# ADDENDUM

## User's Reference Guide—Basic Reference Section

# Standard Keyboard Overlay Change

### User's Reference Guide — Page 186

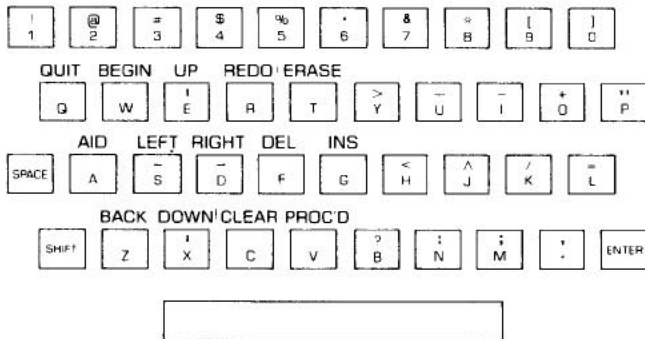
Line 510 of the Character Definition program should be:

```
>510 LOW=B(R,5)*8+B(R,6)*4+B(  
  R,7)*2+B(R,8)+1
```

Please mark this correction in your manual.
